**Comment Letter 0034 Continued**

Oceanside to San Diego

**Response to Comments of Kim Delfino, California Program Director, Defenders of Wildlife, August 30, 2004  
(Letter O034)**

**Figure 5.2 Operating Revenue and Costs**

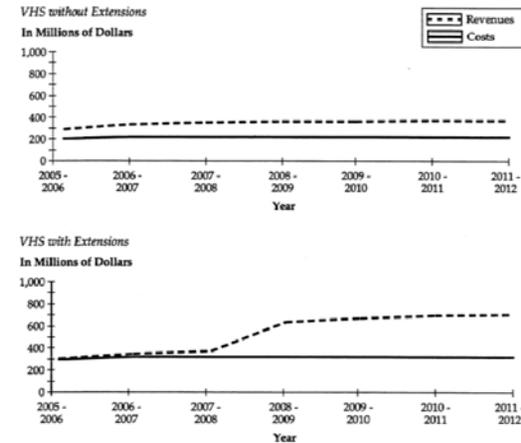
As suggested above, omission of project phasing information is a major failing of this DEIR/S (more on this below). Ridership and environmental studies performed by the predecessor Intercity High Speed Rail Commission through 1996 separately explained two major phases of this project. The first phase of the project is the portion from L.A. to the Bay Area, which would be separately financed partially through an initial statewide bond measure. The second phase includes “extensions” to Sacramento, San Diego, and possible Oakland that presumably would depend in part upon the financial success of the first phase of the project.

The graph below, borrowed from IHSRC’s 1996 Summary Report and Action Plan, suggests the kind of understanding that can be gleaned from analyzing each phase of the project:
